# MS-5024UD/MS-5024UDE Field Software Change Procedure

Document 50125 Rev M 7/15/05 ECN 05-429

## Firmware Change

## PROM Replacement

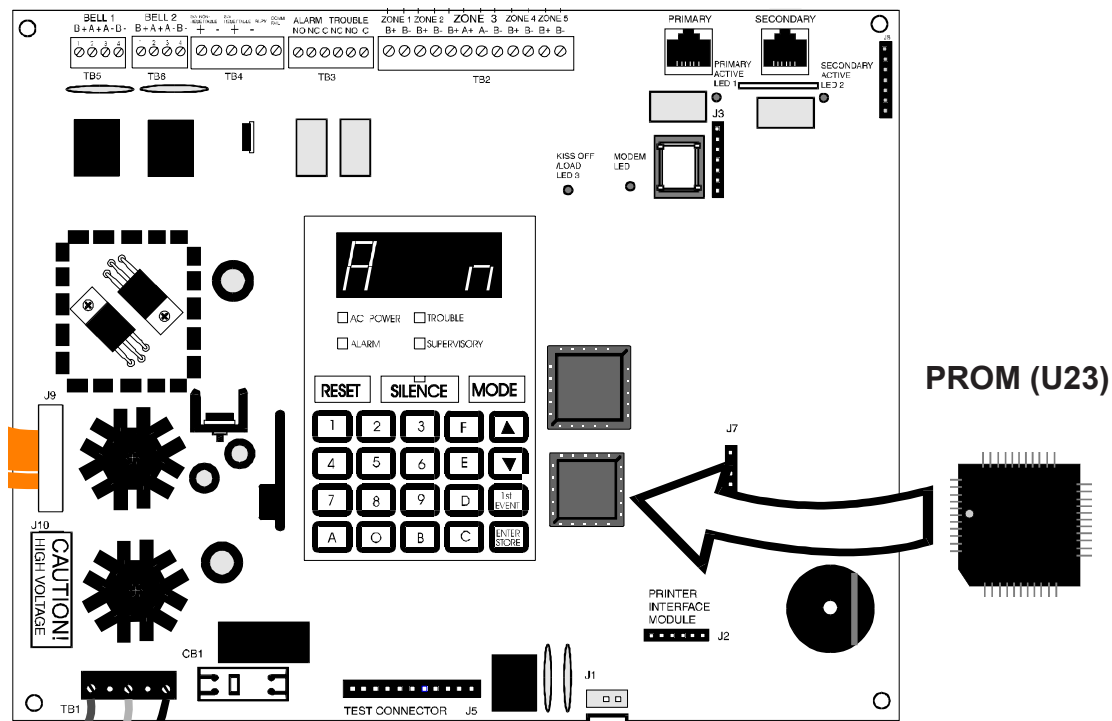
1. Remove all power (AC and battery) before proceeding with PROM replacement.
2. If necessary, disconnect any installed option modules which may inhibit access to PROM.
3. Locate U23 (center right of the board).
4. Gently loosen and remove the PROM from U23.
5. Install the replacement PROM in location U23. Observe proper orientation! The dot on the IC should be positioned to the left and the flattened corner of the IC should align with the flattened corner of the socket. Use care to insure that the PROM's pins are not bent or broken during insertion.
6. Reconnect any option modules which were removed in Step 2.
7. Reconnect power (AC and batteries).
